Date: 10th October, 2008

Mr. Ian Woodward
Chairman, Reliability Panel
Australian Energy Marketing Commission
PO Box A2449
SYDNEY SOUTH NSW 1235

**Frequency Operating Standards for Tasmania -
Interim Frequency Standard Determination Supplementary Submission**

Figure 1 Co-optimised CCGT dispatch duration curve

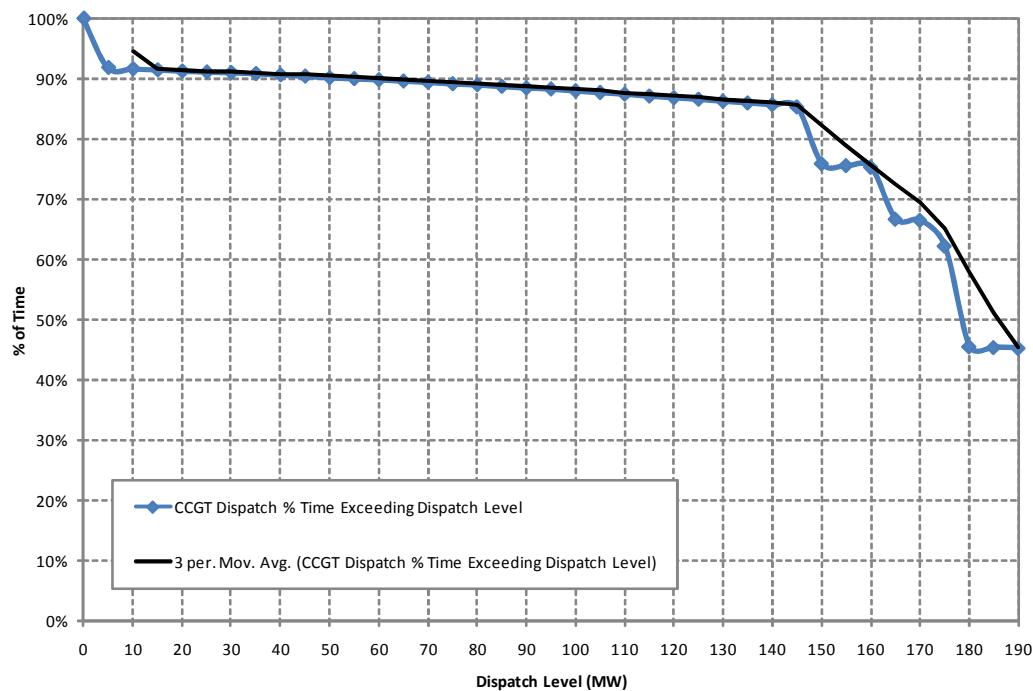
In spite of this policy preference the Panel has proposed a fixed limit on generator size (144MW). The basis of the 144MW seems to be that it is the existing limit. Analysis detailed in submissions posted on the AEMC website suggests significantly higher limits could apply for large periods of time (Alinta Energy (Tamar Valley) secondary submission).

Fixing the largest generating contingency is poor policy because it:

- 1 does not acknowledge the dynamic nature of the contingency issue;
- 2 restricts the possibility of market outcomes to the generator contingency limit;
- 3 requires a modification of the Frequency Operating Standard by the Reliability Panel rather than allowing the limit to be varied as part of the management process of the system.

We believe that formal authority should be given to NEMMCO to formulate a constraint equation to determine the maximum dispatchable generator in each trading period, for inclusion in the NEMDE dispatch process. This approach is also consistent with the way that similar size issues are managed currently by NEMDE. For example, constraints that limit generator output and loadings of transmission lines to be less than the ratings are managed by constraint formulations. There are no restrictions placed within NER or reliability standards on the size of transmission lines to be built or generators to be installed. Bigger sized transmission lines and generators are currently registered and effectively operated without any need to specify maximum size in the standard. The inclusion of a specific unit size of 144MW is a major departure from this, and will cause a significant barrier to bringing efficient plant into Tasmania.
